Intel[®] Pentium[®] 4 Processor in 478-pin Package and Intel[®] 845GE/845PE Chipset

Platform Design Guide Update

August 2004

Document Number: 252396-004

Table 12-2. Platform System Clock Cross Reference

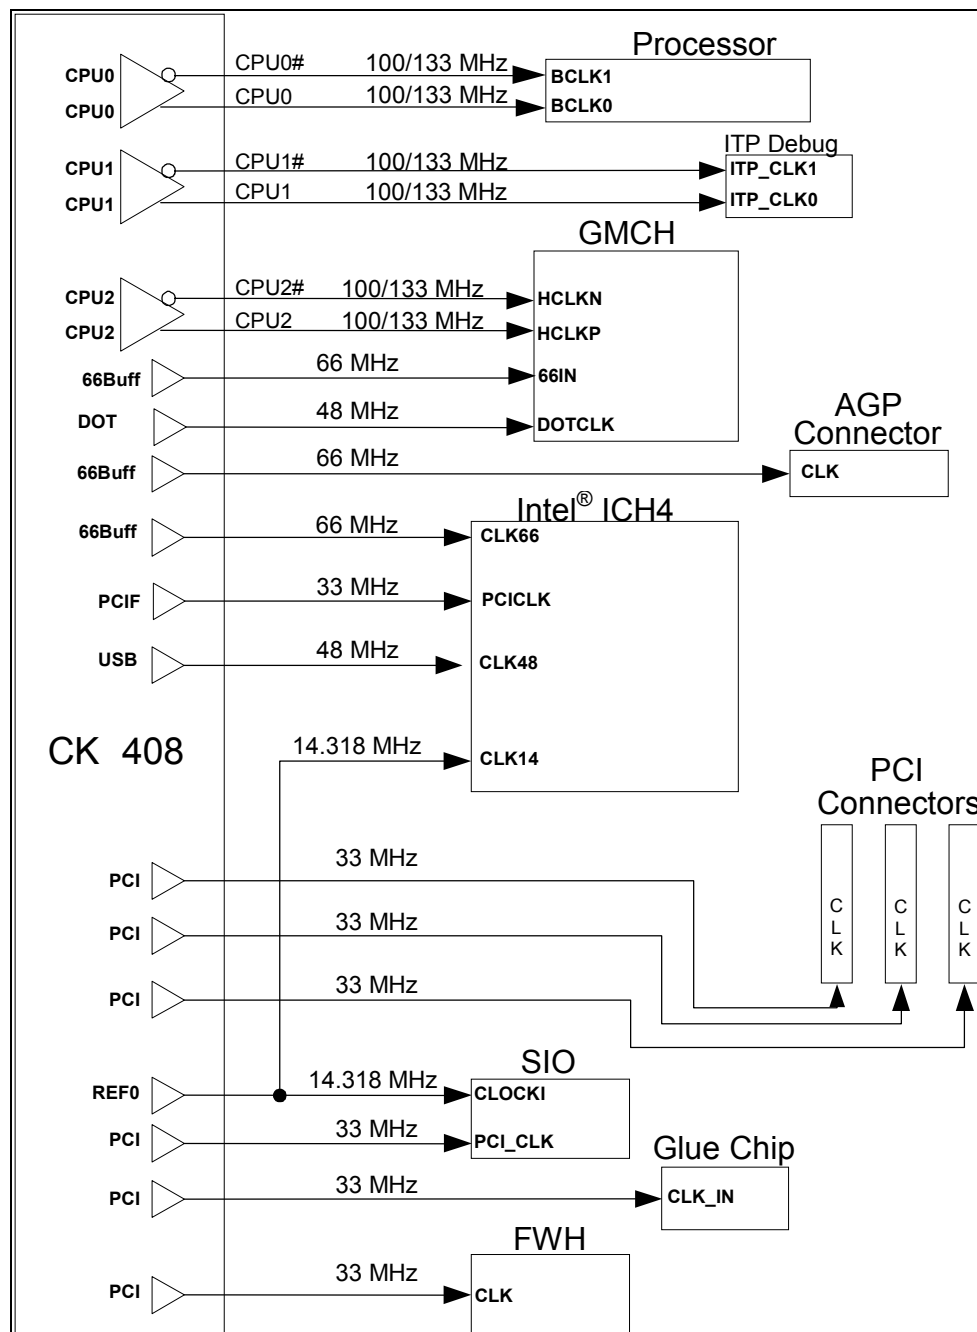
(1) Reference Section 12, *Platform Clock Routing Guidelines*. Replace Table 12-2, *Platform System Clock Cross-Reference*, with the following new table:

Clock Group	CK-408 Pin	Component	Component Pin Name
HOST_CLK	CPU0	CPU	BCLK0
	CPU0#	CPU	BCLK1
	CPU1	ITP Debug Port	BCK
	CPU1#	ITP Debug Port	BCK#
	CPU2	(G)MCH	HCLKP
	CPU2#	(G)MCH	HCLKN
DOT_CLK	DOT_48 MHz	GMCH (845GE chipset only)	DREFCLK
CLK66	3V66	(G)MCH	GCLKIN
		Intel® ICH4	CLK66
AGPCLK	3V66	AGP Connector or AGP Device	AGPCLK
CLK33	PCIF	Intel® ICH4	PCICLK
	PCI	SIO	PCI_CLK
	3V66	Glue Chip	CLK_IN
	PCI	FWH/Flash BIOS	CLK
CLK14	REF0	ICH4	CLK14
		SIO	CLOCKI
PCICLK	PCI	PCI Connector #1	CLK
		PCI Connector #2	CLK
		PCI Connector #3	CLK
USBCLK	USB_48MHz	ICH4	CLK48

Figure 8-2. Hub Interface Single HI_REF/HI_SWING Generation Circuit

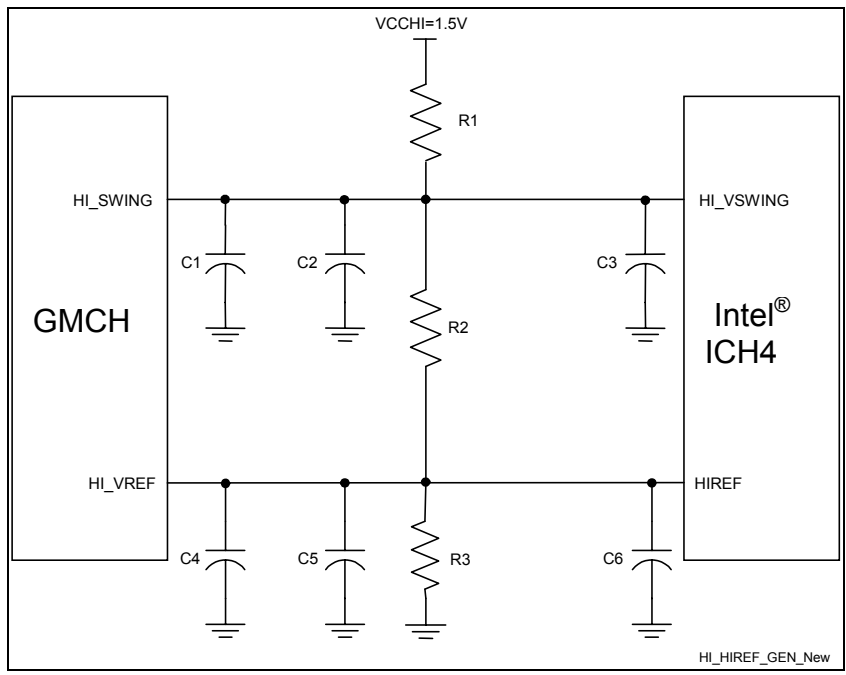
Replace Section 8.1.4, *Hub Interface HI_REF/HI_SWING Generation/Distribution* with the following new section. The new material includes a new Table 8-1 and new Figures 8-2 and 8-3.

HI_REF is the Hub Interface reference voltage. The ICH4 uses HI_VSWING to control voltage swing and impedance strength of the hub interface buffers. The GMCH HI_REF and HI_SWING voltage requirement and associated resistor/capacitor recommendations for the voltage divider circuit are listed in Table 8-1. Only one of the two HI_VSWING values (700 mV or 800 mV) should be used. It is suggested that 800 mV be used on new designs. Any new design using either 700 mV or 800 mV should be validated.

HIREF (V)	Recommended Values for the HIREF / HI_VSWING Divider Circuit (Ω)	
350 mV +/- 2% at 1.5 V nominal	Using HI_VSWING Spec of 800 mV \pm 2% at 1.5 V Nominal (Recommended)	Using HI_VSWING Spec of 700 mV \pm 2% at 1.5 V Nominal (Requires System Validation)
	Option 1 (Figure 8-2 and Figure 8-3) R1 = 226 $\Omega \pm 1\%$, R2 = 147 $\Omega \pm 1\%$, R3 = 113 $\Omega \pm 1\%$ Option 2 (Figure 8-2 and Figure 8-3) R1 = 80.6 $\Omega \pm 1\%$, R2 = 51.1 $\Omega \pm 1\%$, R3 = 40.2 $\Omega \pm 1\%$ Option 3 (Figure 8-2 and Figure 8-3) R1 = 255 $\Omega \pm 1\%$, R2 = 162 $\Omega \pm 1\%$, R3 = 127 $\Omega \pm 1\%$ Capacitance Values For All Options C1 and C3 = 0.1uF (near divider) C2, C4, C5, C6 = 0.01uF (near component)	Option 1 (Figure 8-2 and Figure 8-3) R1 = 226 $\Omega \pm 1\%$, R2 = 100 $\Omega \pm 1\%$, R3 = 100 $\Omega \pm 1\%$ Other options are available using Figure 8-2 and Figure 8-3 by changing resistor values to achieve the correct voltage. Capacitance Values For All Options C1 and C3 = 0.1uF (near divider) C2, C4, C5, C6 = 0.01uF (near component)

The resistor values, R1, R2, and R3, must be rated at 1% tolerance. The selected resistor values ensure that the reference voltage tolerance is maintained over the input leakage specification. Two 0.1 μ F capacitors (C2, C5) should be placed close the divider. In addition, the 0.01 μ F bypass capacitors (C1, C3, C4, C6) should be placed within 0.25 inch of the component HI_REF/VREF pin (for C3 and C4) and HI_SWING pin (for C1 and C6). The max distance from the voltage divider resistor network to the device is 4 inches (less is better). Normal care must be taken to minimize crosstalk to other signals (< 10–15 mV). Two examples of the HI_REF/HI_VSWING voltage divider circuits are Figure 8-2 and Figure 8-3. If the single HI_REF/HI_SWING divider circuit is located more than 4 inches away from the divider network, the locally generated reference divider (Figure 8-3) should be used.

Figure 9-40. Example Intel® 82562EZ/ET/EX/EM Disable/Power Down Circuitry

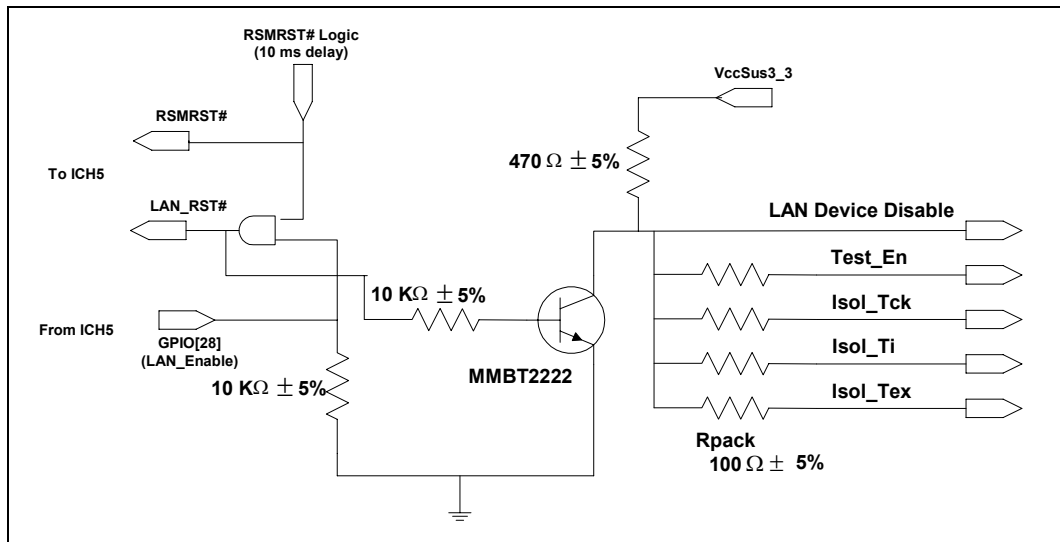
Section 9.10.1, *Intel® 82562EZ/ET/EX/EM Disable Guidelines*, is replaced with the following:

To power down the Intel® 82562EZ/ET/EX/EM, the device must be isolated (disabled) prior to or during reset (LAN_RST#) asserting. Using a GPIO, such as GPIO[28] to be LAN_Enable (enabled high), LAN will default to enabled on initial power-up and after an AC power loss, since GPIO[28] is high during and after reset. The example circuit shown below will correct this behavior. The BIOS controlling the GPIO can disable the LAN PHY.

Note: LAN_RST# needs to be held low for 10 ms after power is stable. It is assumed that the RSMRST# logic will provide this delay. Because GPIO[28] will default to high on power up, an AND gate has been implemented to ensure the required delay for LAN_RST# is met.

- Test_En should be pulled-down thru a 100 Ω resistor.
- The remaining 3 control signals should each be connected thru 100 Ω series resistors to the common node “Intel® 82562EZ/ET/EX/EM_Disable” of the disable circuit.

Figure 13-1. Intel® 845GE/845PE Chipset DDR Platform Power Delivery Map

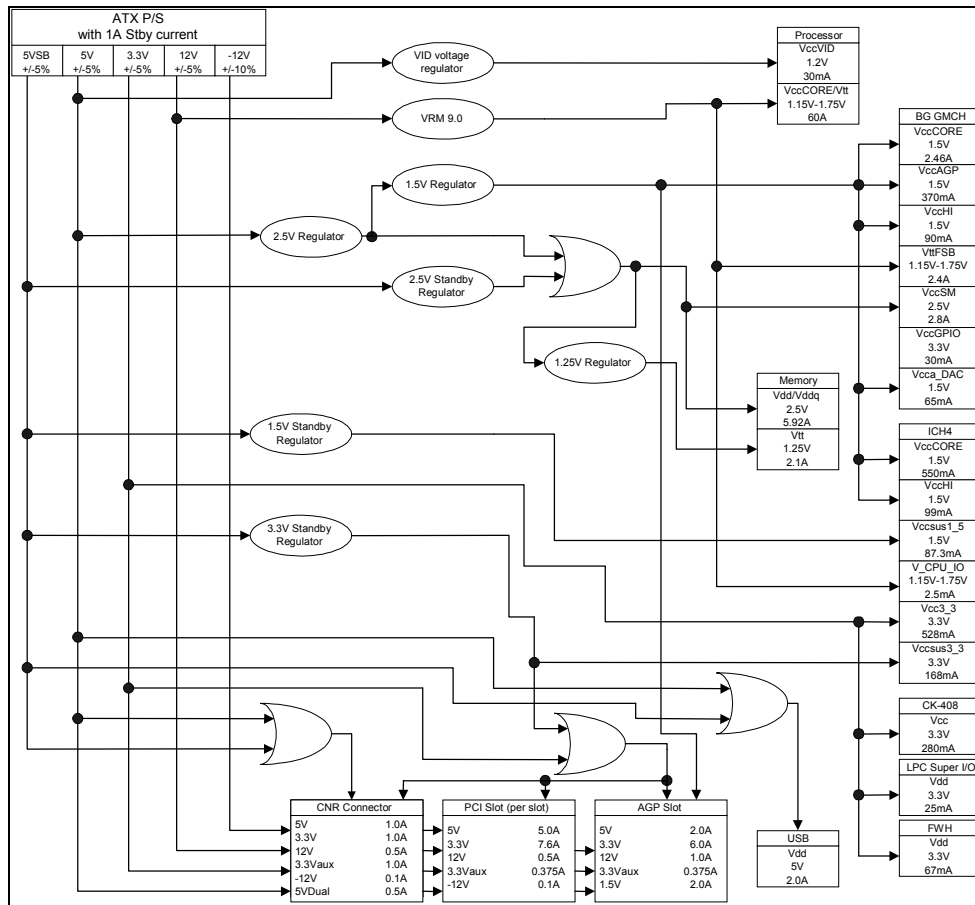
7. Replace the Power Delivery Map in Section 13.1, Figure 13-1, with the following:
